BELL SYSTEM PRACTICES  
Outside Plant Construction  
and Maintenance

ADDENDUM G10.400  
Issue B, March, 1948-S

GENERAL  
KS-8455 TEST SET

KS-8455 TEST SET

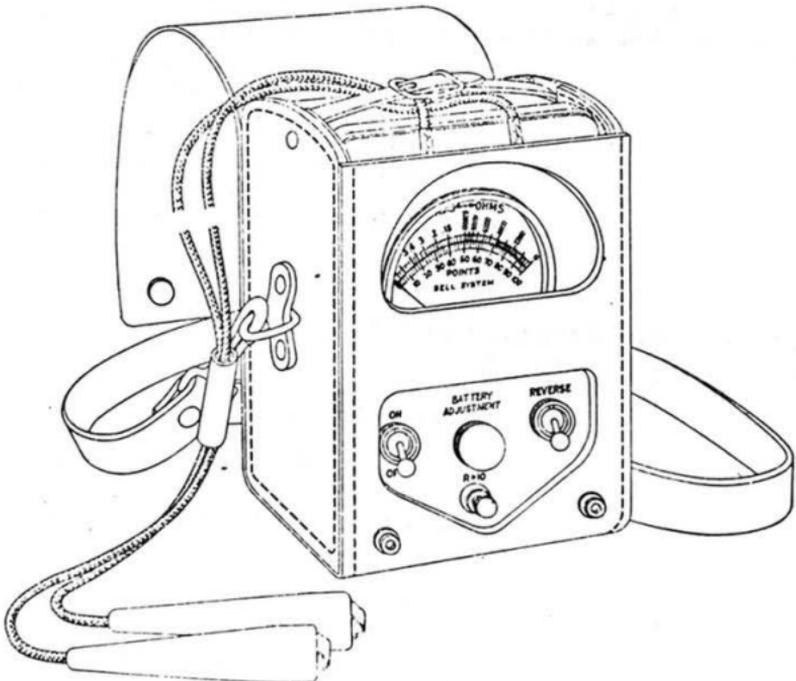
2.01 (a) The KS-8455 Test Set and leather carrying case are illustrated below:

The KS-8455 Test Set is made up of the following parts:

- (1) KS-8455 Test Set, List 1 - Complete set except battery.
  - (2) KS-8455 Test Set, List 2 - Volt-Chmmeter only.
  - (3) KS-8456 Carrying Case
  - (4) Two WIAH Cords
  - (5) No. 455 Eveready Battery
- (b) The 89A Test Set consists of a complete set, except the battery, and includes the following parts:
